# UNITED STATES PATENT AND TRADEMARK OFFICE

APPLICATION NO.	FILING DATE	FIRST NAMED INVENTOR	ATTORNEY DOCKET NO.	CONFIRMATION NO.
10/812,359	03/30/2004	Youichi Zenda	001309.00060	4112

**Office Action Summary**

## **DETAILED ACTION**

**Figure 1, Annotated  
From Rapp (4,659,237)**

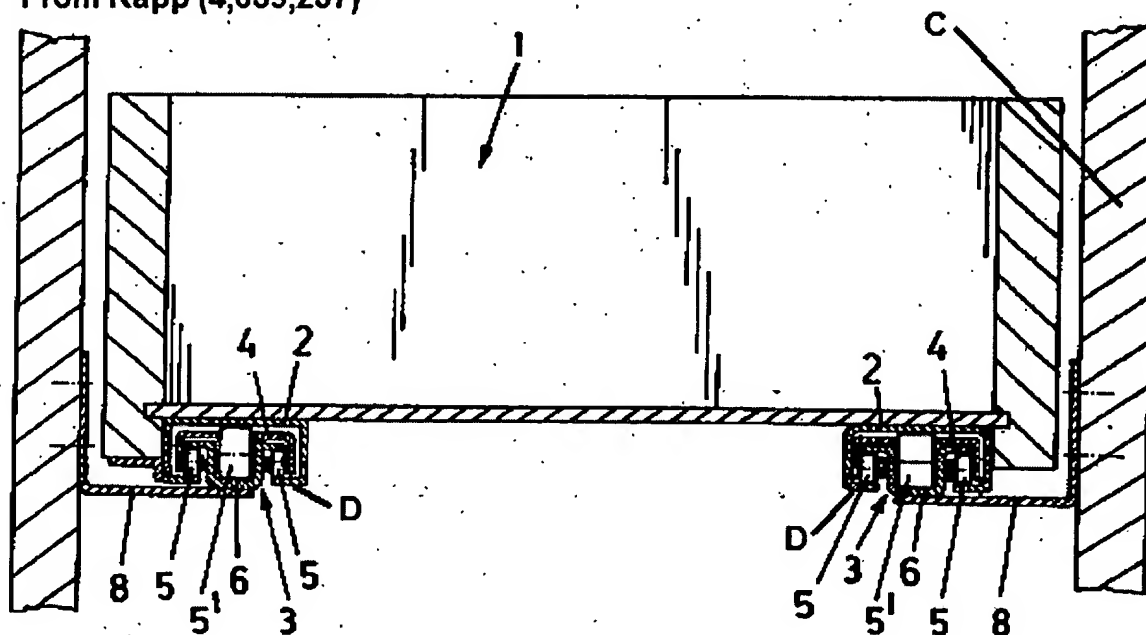
57. Regarding claim 1, Rapp teaches a structure wherein at least a rear end side of an object (1) is supported in a box body (Item C in Figure 1 Annotated) in a manner movable along back and forth and a front end side thereof is supported in a manner movable along back and forth by a floor (6) at least through a rolling supporting body (5') so as to draw the object forward from a stored position in the box body (C), and characterized by that the rolling supporting body adopts

a free motion rotating body (5') whose upper end makes an abutting contact with a downward facing surface (2) of the object (1) and whose bottom end contacts the floor (6), and the free motion rotating body (5') supports the front end side of the object with making a rolling movement at a half traveling speed of the object. The examiner points out that, due to basic physics, the free motion rotating body (5') will inherently move at a half traveling speed of the object (1) when said object is moved horizontally.

58. Regarding claim 3, Rapp teaches a structure wherein the free motion rotating body (5') contacts the downward facing surface (2) of the object (1) and the floor (6) through an endless track (i.e., the outer surface of Item 5').

59. Regarding claim 4, Rapp teaches a structure wherein the free motion rotating body (5') is supported by the object (1) in a manner capable of being suspended through a rail (Item D in Figure 1 Annotated) and a rotor (5).

60. Regarding claim 6, Rapp teaches a structure wherein the free motion rotating body (5') is supported by the object (1) in a manner capable of being suspended through a rail (Item D in Figure 1 Annotated) and a rotor (5).

61. Claims 14 and 15, as best understood, are rejected under 35 U.S.C. 102(b) as anticipated by or, in the alternative, under 35 U.S.C. 103(a) as obvious over Rapp (4,659,237). Rapp teaches the structure substantially as claimed, including a drawer (1) arranged at the lowest part of the box body (Item C in Figure 1 Annotated), said box body being a drawer storage portion.

Additionally, whereas the utilization of structures such as that taught by Rapp in desks with drawers is well-known in the art – see, for example, Grieser (5,785,400), Gutner (4,305,625), Brodbeck (2,327,761), and Harmon (2,950,158) – it would have been obvious to replace Item C

of Figure 1 Annotated with a drawer storage portion of a desk in order to provide structural support to a desk drawer while preserving the horizontal mobility thereof, thereby providing the structure substantially as claimed.

Figure 3, Annotated  
From Onomoto (5,046,790)

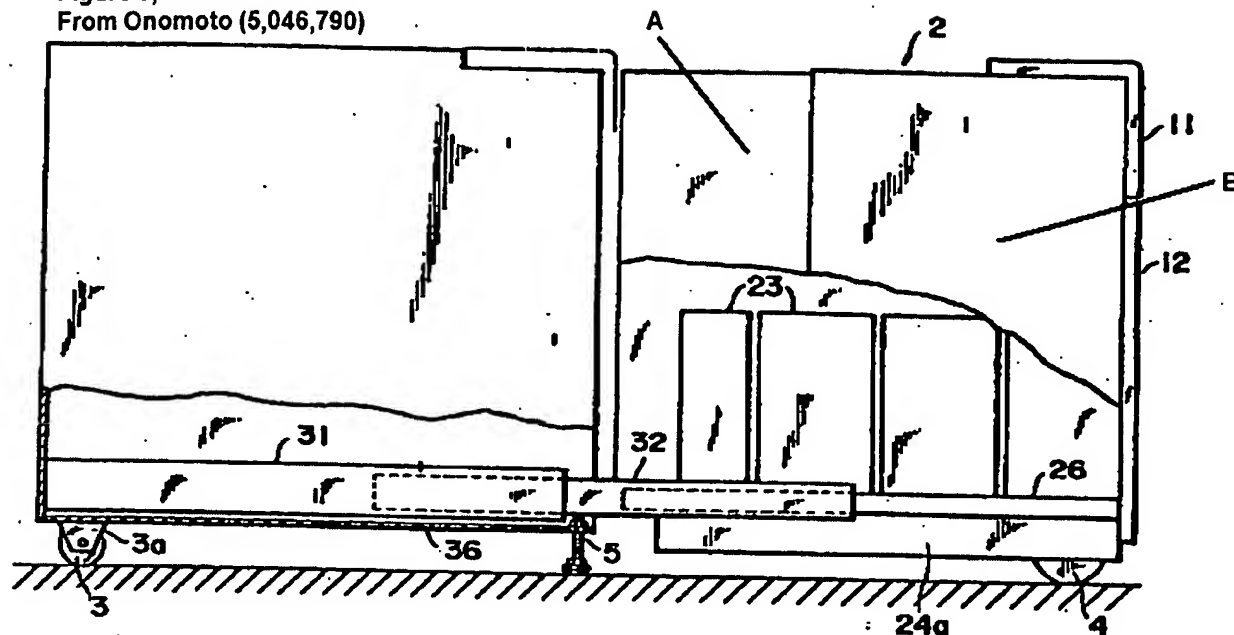
62. Claims 1, 3, 4, 6, 14, and 15, as best understood, can be alternately rejected, along with claims 16 and 17, as best understood, under 35 U.S.C. 103(a) as being unpatentable over Onomoto (5,046,790) in view of Reaney (5,779,067). Onomoto teaches the structure substantially as claimed, including a structure wherein at least a rear end side (Item A in Figure 3 Annotated) of an object (2) is supported in a box body (1) in a manner movable along back and forth and a front end side thereof is supported in a manner (Items 26 and 31-34) movable along back and forth by a floor at least through a rolling supporting body (4) so as to draw the object (2) forward from a stored position (see Figure 2) in the box body (1), and characterized in that the rolling supporting body includes a free motion rotating body (4) whose bottom end contacts the floor (see Figures 2-5), said free motion rotating body supporting the front end side (Item B in Figure 3 Annotated) of the object (2); said free motion rotating body being supported by the object in a manner capable of being suspended through a rail (31) and a rotor (33); wherein the object (2) is a drawer (see Figure 3) and the box body (1) is a drawer storage portion of a wagon equipped with a drawer (see Figures 1-3); and wherein the drawer (2) is arranged at the lowest part of the drawer storage portion (1).

63. The only difference between Onomoto and the invention as claimed is that Onomoto fails to teach a structure comprising a free-motion rotating body whose upper end that makes an abutting contact with a downward facing surface of the object, and that makes a rolling movement at a half traveling speed of the object; said free motion rotating body contacting the downward facing surface of the object and the floor through an endless track; and wherein the drawer has an arrangement in which each upper part of three sides of a bottom wall is surrounded by a standing wall and an upper part of one side thereof that is orthogonal to a direction accessible to an article to be stored is open.

**Figure 2, Annotated  
From Shapleigh (3,613,566)**

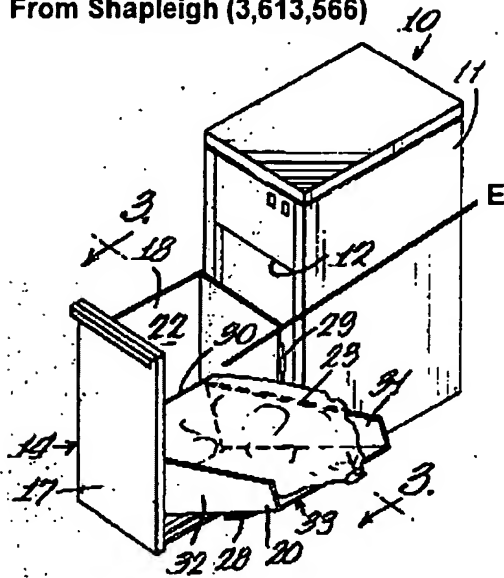
71. Claims 16 and 17, as best understood, can be alternately rejected under 35 U.S.C. 103(a) as being unpatentable over Rapp (4,659,237) in view of Shapleigh (3,613,566). Rapp teaches the structure substantially as claimed, including a drawer (1) arranged at the lowest part of the drawer storage portion (Item C in Figure 1 Annotated); the only difference being, Rapp fails to teach a drawer that has an arrangement in which each upper part of three sides of a bottom wall is surrounded by a standing wall and an upper part of one side thereof that is orthogonal to a direction accessible to an article to be stored is open. Shapleigh, however, teaches a drawer (22) that has an arrangement in which each upper part of three sides of a bottom wall (21) is surrounded by a standing wall (17, 18, 19) and an upper part of one side (Item E in Figure 2 Annotated) thereof that is orthogonal to a direction accessible to an article to be stored is open. It would have been obvious to one of ordinary skill in the art to replace the drawer in the structure of Rapp with the drawer taught by Shapleigh in order to provide easier access to the objects contained within said drawer, thereby providing the structure substantially as claimed.
